IKARUS C42 Safety belt attachment.

All IKARUS C42 up to and including all built until 04/2001 with release fittings in the shoulder harness.

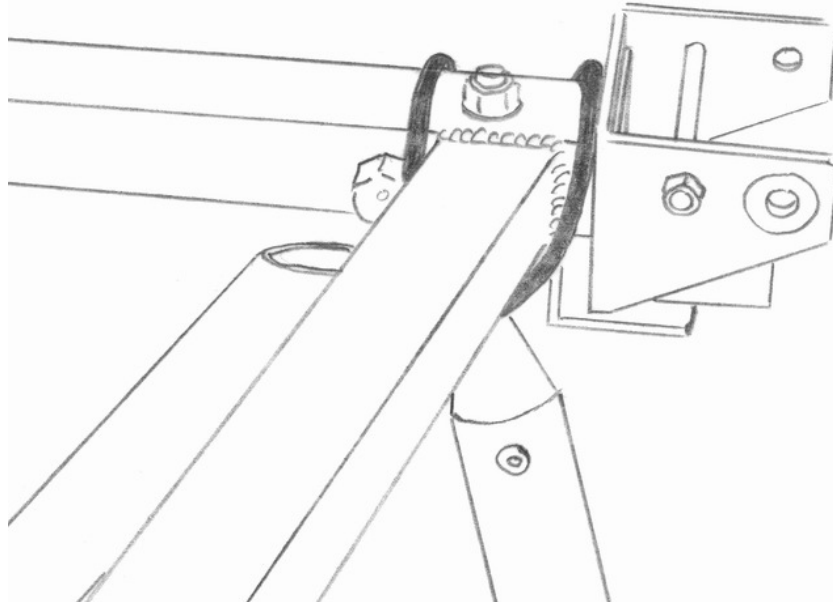
The shoulder harness attachments broke in an accident with an IKARUS C42 aircraft.

Replacement of the upper shoulder harness attachments through the steel wire loops which are available as a retro-fit kit.

The procedures for the replacement of the steel wire loops for both pilot and co-pilot safety harnesses are shown in the accompanying sketch.

The steel wire (1) must be fed from front to back under the longitudinal tube (2) and over the traverse tube. Both ends of the steel wire are then fed down and under each side of the C strut. Under the C strut the wire thimbles are connected via the release fitting (5). The M8 nut (6) in the longitudinal tube (2) is then covered with the accompanying plastic cap.

The accompanying foam rubber strip may be adhered to the release fitting if it rattles.
